STAFF REPORT COMMUNITY DEVELOPMENT DEPARTMENT

HEARING DATE: June 1, 2021
 TO: Mayor & City Council
 FROM: Sonya Allen, Associate Planner
 208-884-5533
 SUBJECT: H-2021-0014
 Artemisia Subdivision – AZ, PP
 LOCATION: 1690 W. Overland Rd., in the SE ¼ of Section 14, T.3N., R.1W. (Parcel #S1214449107)

Annexation and zoning (AZ) of 25.67-acres of land with a C-G (General Retail and Service Commercial) zoning district; and, Preliminary Plat (PP) consisting of 9 commercial buildable lots on 19.26-acres of land in the proposed C-G (General Retail and Service Commercial) zoning district.

LANDSCAPE PLAN
Kendall Site

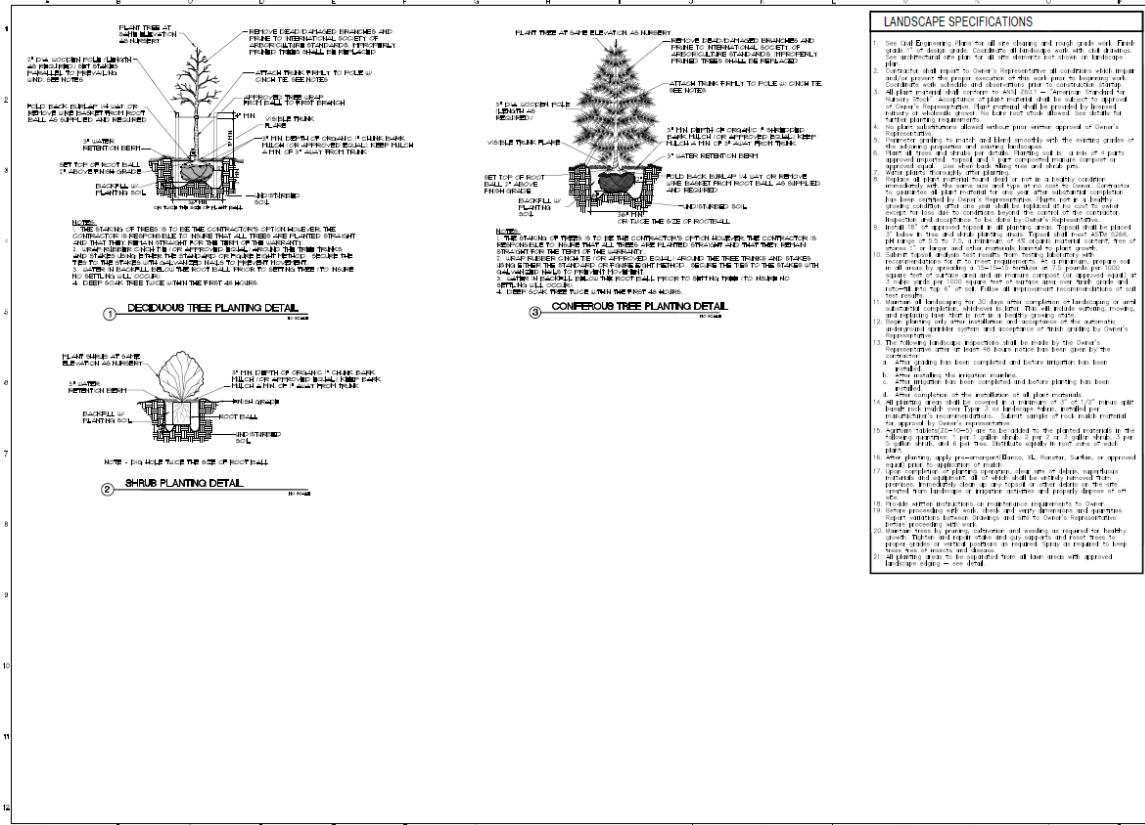
*The landscape plan depicts a pedestrian walkway within the landscape buffers around the perimeter of the development and sidewalks along internal public streets. **Additional internal pedestrian walkways should be provided between buildings within the site for pedestrian connectivity and from the perimeter sidewalks along Overland and Linder Roads to the main building entrances.***

3. The landscape plan submitted with the final plat shall be revised as follows:
 - a. Include a calculations table on the plan that demonstrate compliance with the standards for street buffer ([11-3B-7C](#)), pathway ([11-3B-12C](#)) and parkway ([11-3B-7C](#)) landscaping; include required vs. provided number of trees.

D. Conceptual Building Elevations (dated: 2/2/2021)

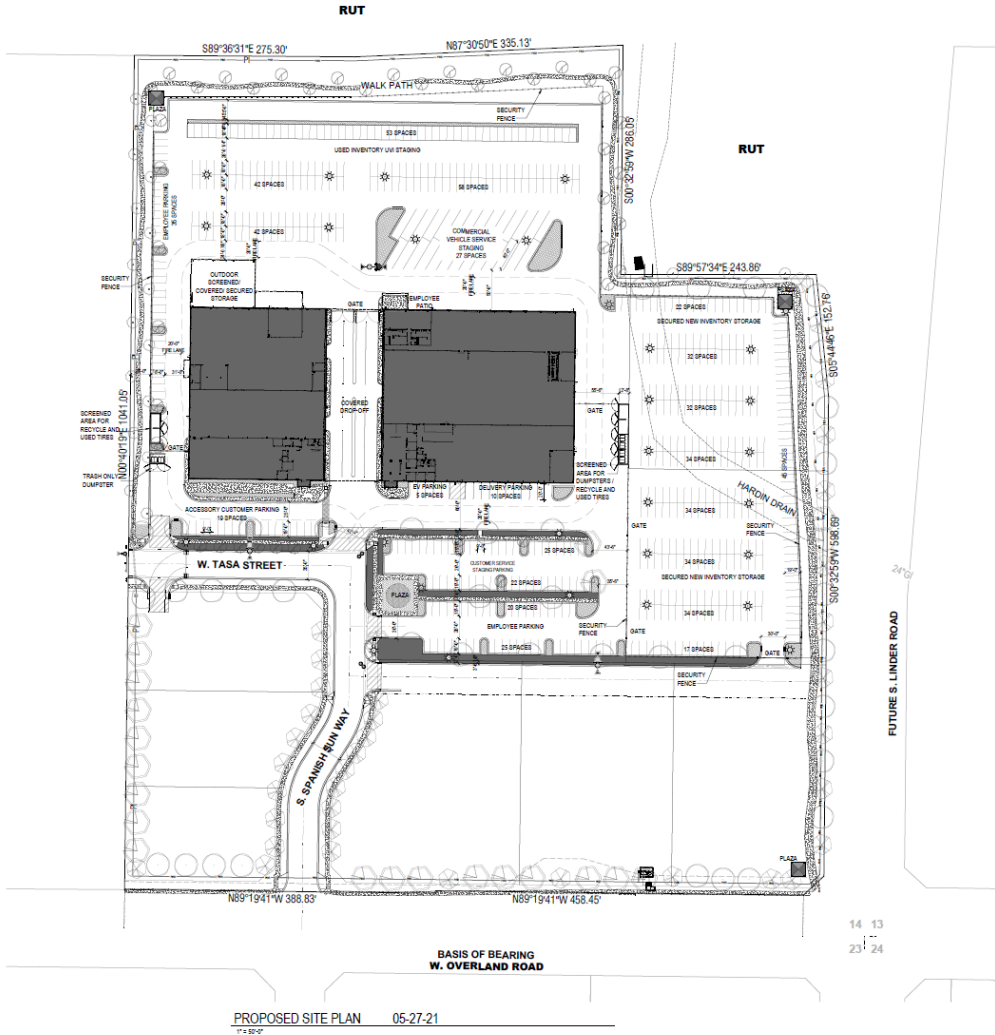
Conceptual building elevations were submitted for the Kendall Ford site as shown in Section VII.D. Two (2) single-story structures are proposed on Lot 1, Block 1 with building materials consisting of ACM panels (i.e. aluminum composite), corrugated horizontal metal panels, CMU in two (2) different colors; metal sunscreens and canopies are proposed over some windows.

Overhead doors are proposed on the north, east and west sides of the building. **Final design must comply with the design guidelines in the TMISAP and the design standards in the Architectural Standards Manual.**
